Notification of Non-Compliant Appeal Brief
(37 CFR 41.37)

Application No. 10/645,035		Applicant(s) RING ET AL.	
Examiner Melody M. Burch		Art Unit 3683

IN THE UNITED STATES PATENT AND TRADEMARK OFFICE
BEFORE THE DIRECTOR

For: UNIVERSAL BRAKE ASSEMBLY

FIG. 3

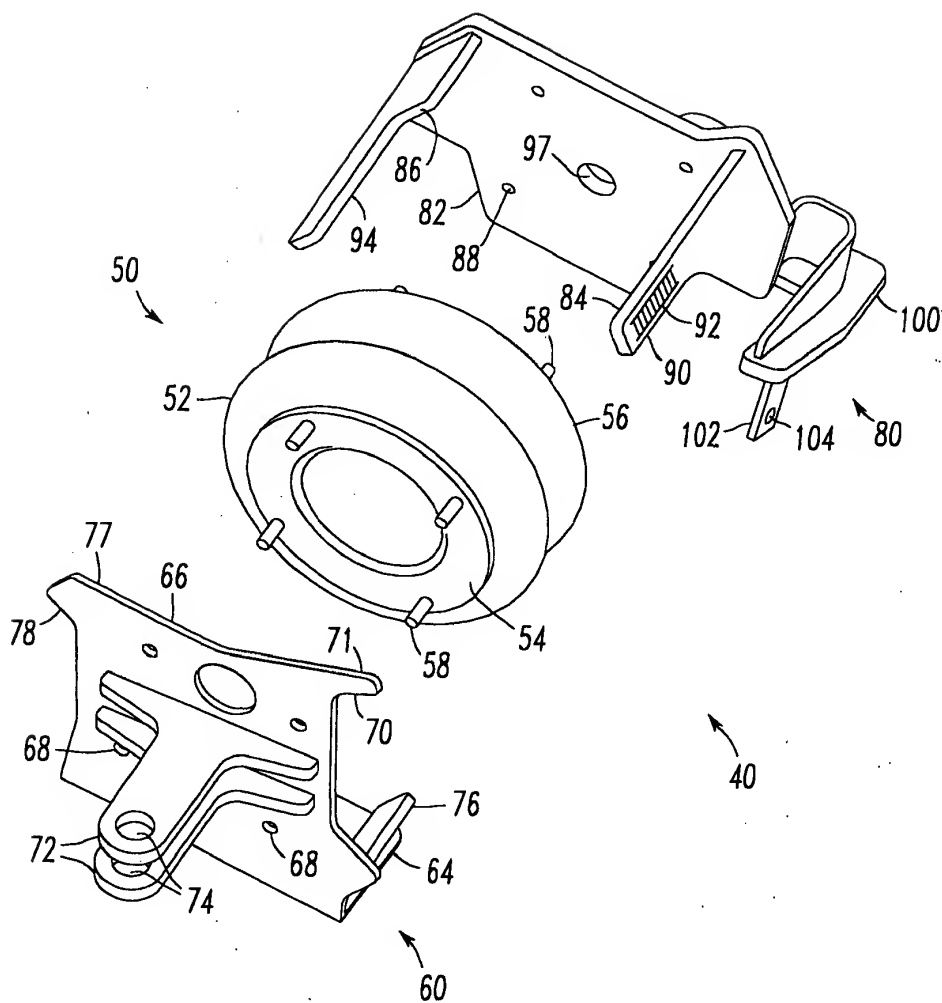
In the Office Action mailed on October 30, 2006, the Examiner objected to the drawings under 37 CFR 1.83(a) because they do not show every feature of the invention specified in the claims.

Attachment: Figure 3
